UNITED STATES PATENT AND TRADEMARK OFFICE

10/622,491

Office Action Summary	Application No. 10/622,491	Applicant(s) ROBERTS, BRIAN	
	Examiner Justin M. Larson	Art Unit 3782

DETAILED ACTION

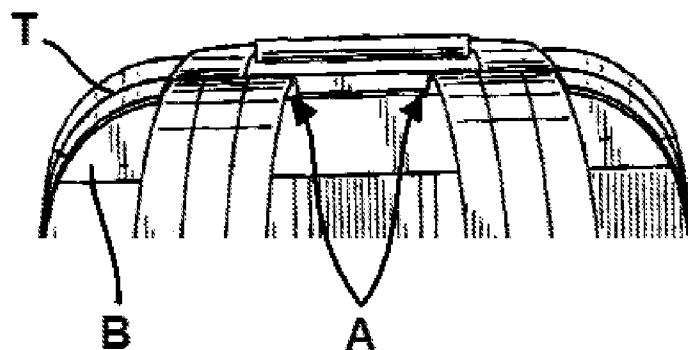
Regarding claims 38, 42, 44, 48, the back-facing face of the modified Ivarson et al. backpack has a top end (T, figure below) and the shoulder strap is connected to the back-facing face (B, figure below) at a position (A, below) spaced from the top end of the back-facing face.
